#### **Addendum 106 – UN Regulation No. 107**

#### **Revision 8 - Amendment 4**

#### **Uniform provisions concerning the approval of category M<sub>2</sub> and M<sub>3</sub> vehicles with regard to their general construction**

Model A

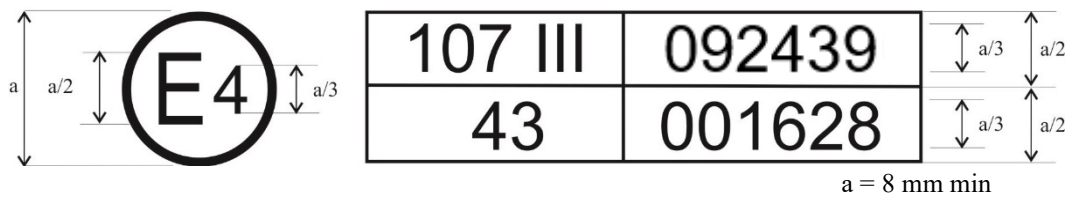
The above approval mark affixed to a vehicle shows that the vehicle type concerned has, with regard to its constructional features, been approved in the Netherlands (E 4) for Class III, pursuant to UN Regulation No. 107 under approval number 092439. The approval number indicates that the approval was granted according to the requirements of UN Regulation No. 107 as amended by the 09 series of amendments.

#### Model C

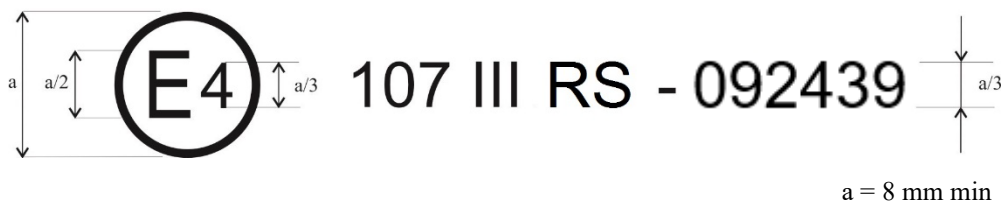
The above approval mark affixed to a vehicle bodywork shows that the bodywork type concerned has, with regard to its constructional features, been approved separately in the Netherlands (E 4) for Class III as a separate bodywork (letter S), pursuant to UN Regulation No. 107 under approval number 092439. The approval number indicates that the approval was granted according to the requirements of UN Regulation No. 107 as amended by the 09 series of amendments."
